Memorandum

To:	Stillwater Town Board	Reference:	Lynskey Subdivision Application - Preliminary and Final Plat for
Copies To:	<hr/> Kathy Schmoeckel , Clerk <hr/> Soren Mattick, Attorney <hr/> Mick Lynskey, "Applicant"	Project No.:	<hr/> 17124.000 Lynskey Plat <hr/>
From:	<hr/> Merritt Clapp-Smith, Planner	Routing:	<hr/> <hr/>
Date:	<hr/> May 6, 2019		<hr/>

SUBJECT: Subdivision request to split a 42.55 acre parcel into four single-family lots.

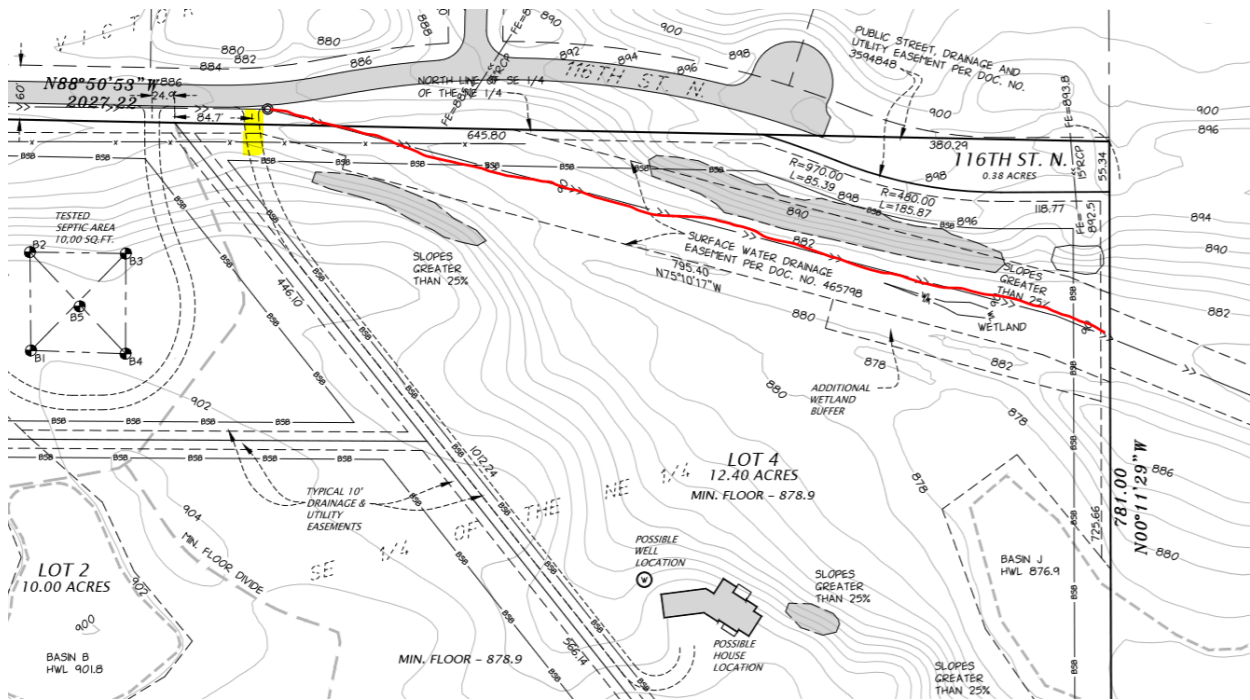
This finding is mostly met. Easement areas are marked on the plat documents and will not be impinged upon by future buildings, drives or septic systems, except as noted below:

- The Little Carnelian outlet easement on Lot 4, which is monitored by the Watershed District, may be crossed by a future driveway, if a crossing easement and associated conditions are approved by the Watershed District.

The image on the next page from the Preliminary Plat has been marked in red pen to indicate the location of the outlet channel for Little Carnelian Lake, running west to east near the north edge of Lot 4. The location where a driveway may cross the easement is marked in yellow.
